Wisconsin Department of Transportation

**Proposal #24: 1229-04-74, WISC 2022106
I-43 North South Freeway
W County Line Road Interchange
IH 43
Milwaukee and Ozaukee Counties**

This is Addendum No. 01, which provides for the following:

ADDENDUM NO. 01

Addendum No. 01
ID 1229-04-74
Revised Sheet 320
November 23, 2021

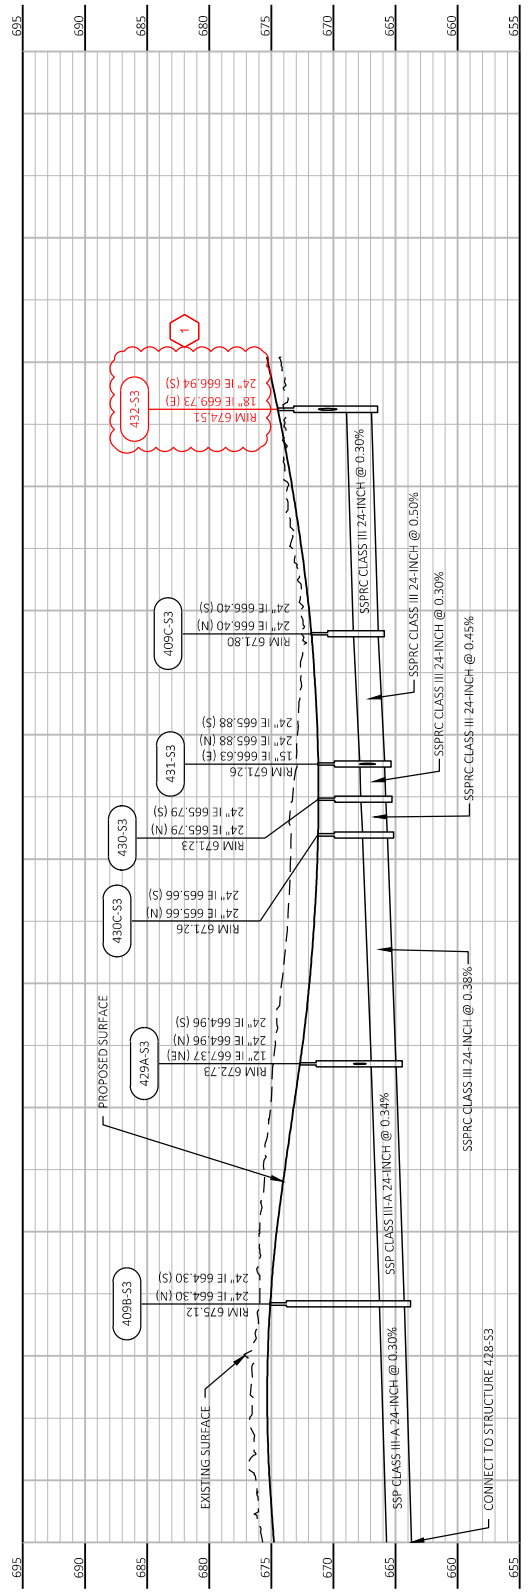
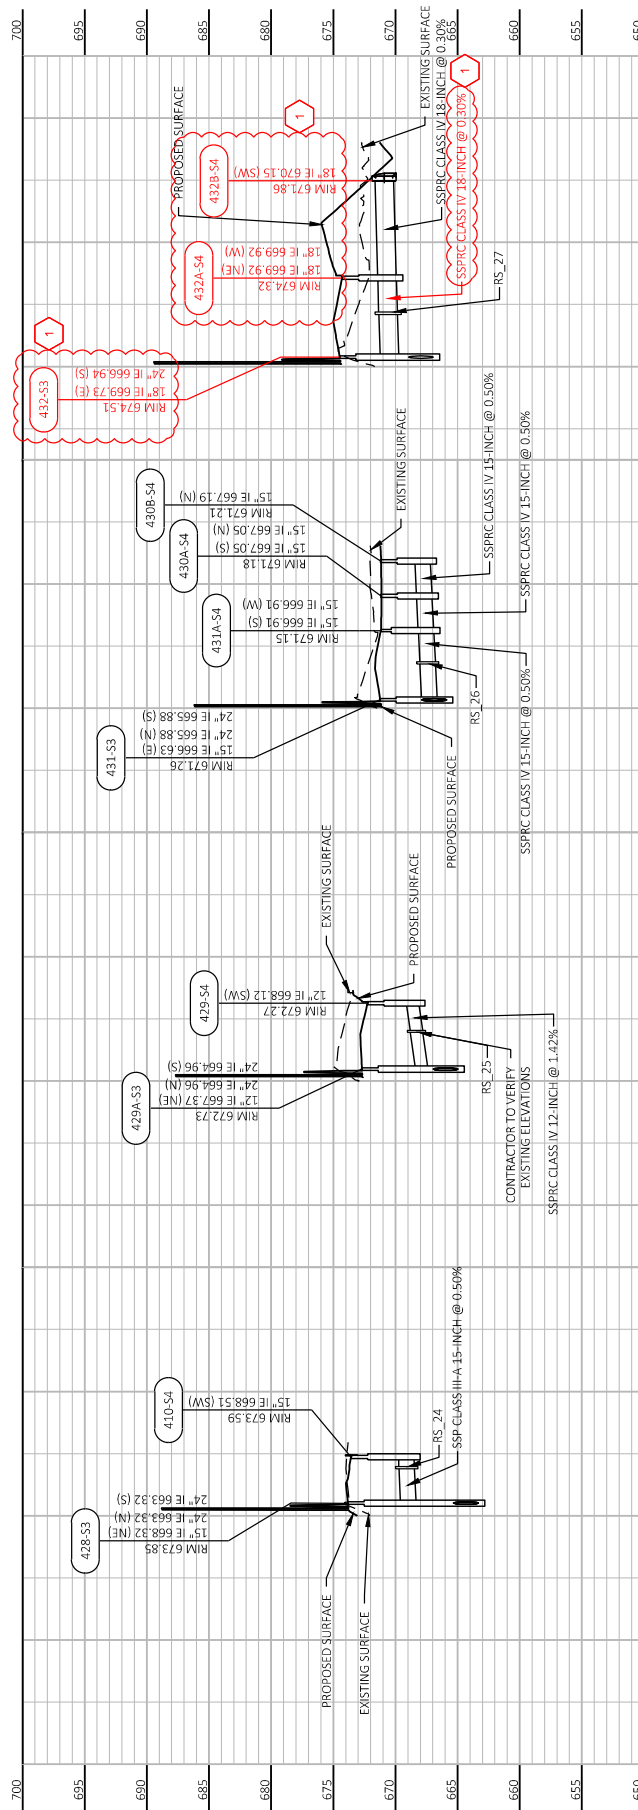
Revised Plan Sheets	
Plan Sheet	Plan Sheet Title (brief description of changes to sheet)
320	Proposed Drainage Plan (Converted ditch inlet to endwall to avoid proposed water utility)
321	Proposed Drainage Profile (Converted ditch inlet to endwall to avoid proposed water utility)
340	Proposed Port Washington Pond Details (Extended rip rap limits to bottom of safety shelf, removed overflow weir) reams
341	Proposed Port Washington Pond Details (Extended Seed Mix No. 30 and Erosion Mat to halfway down safety shelf)

Addendum No. 01
ID 1229-04-74
Added Sheet 343A
November 23, 2021

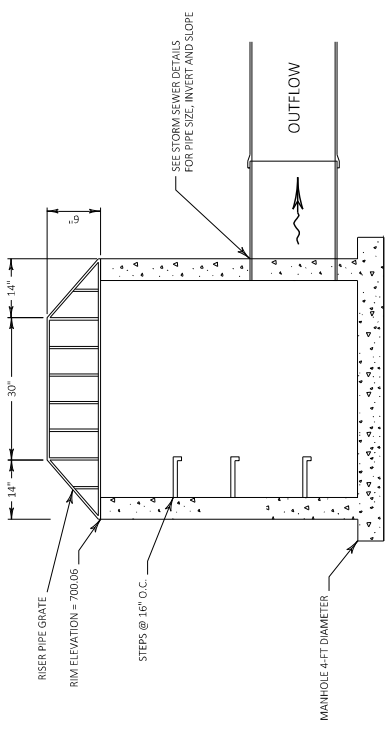
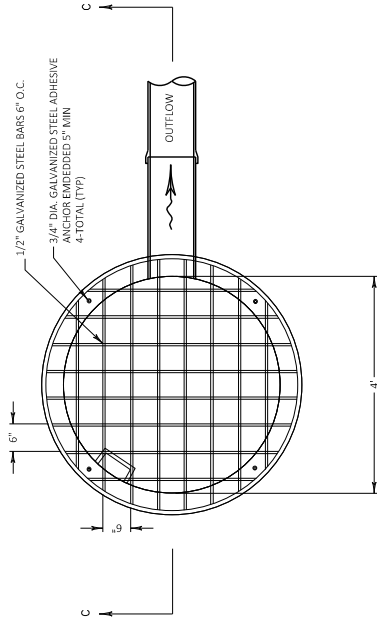
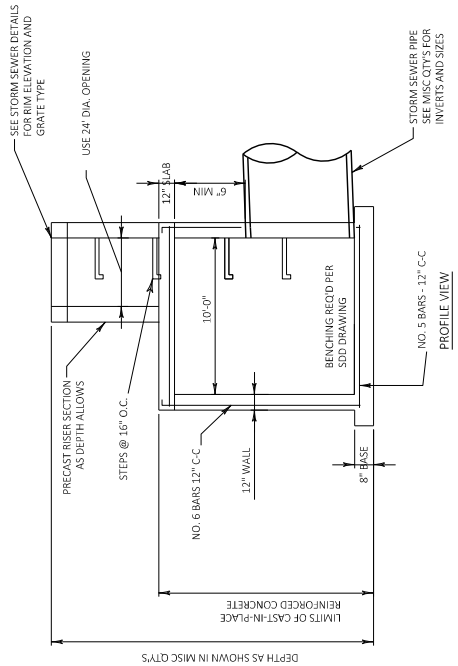
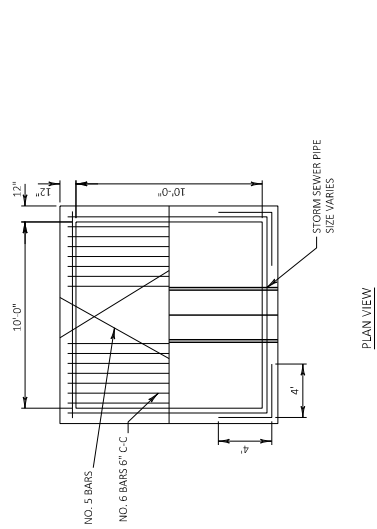
Plan Sheet	Plan Sheet Title (brief description of why sheet was added)
343A	Drainage Construction Details (Manhole 10'x10', Manhole 4' Riser Pipe)
343B	Drainage Construction Details (Inlet Type Tee Special)
1393A-1393H	R-45-44 Plans (Replacing B-45-44)

Addendum No. 01
ID 1229-04-74
Deleted Sheet 1392
November 23, 2021

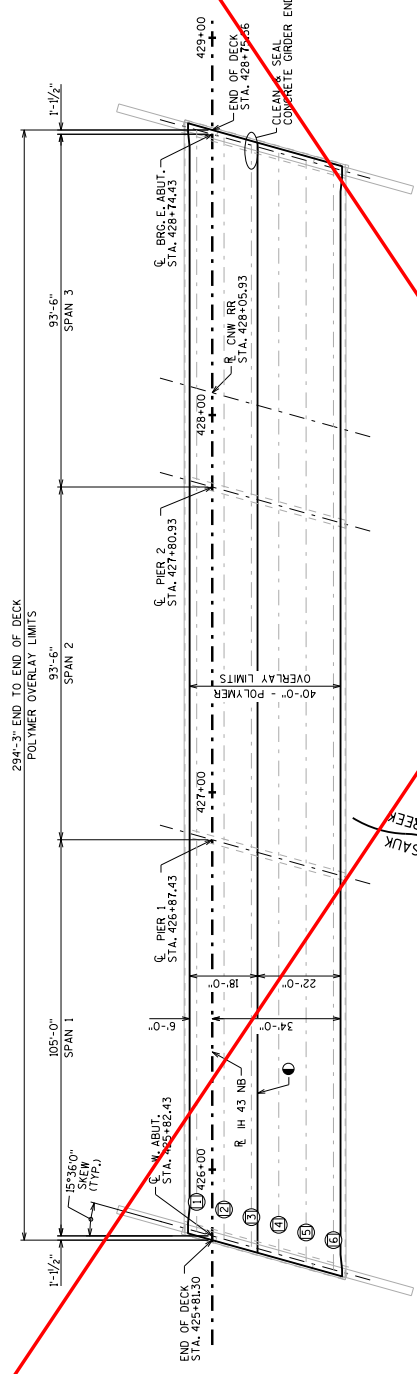
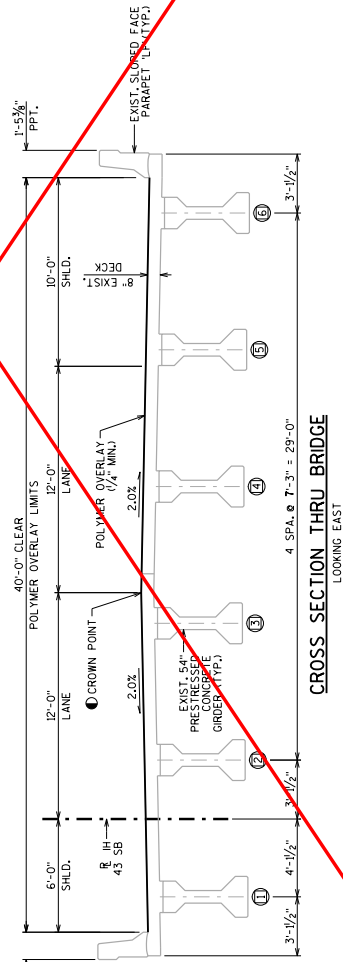
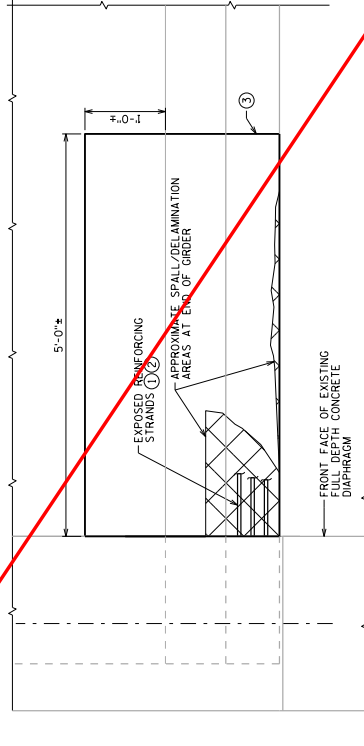
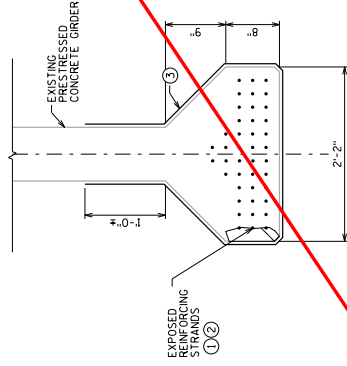
Plan Sheet	Plan Sheet Title (brief description of why sheet was deleted)
1392-1393	B-45-44 Plans (Replaced with R-45-44)
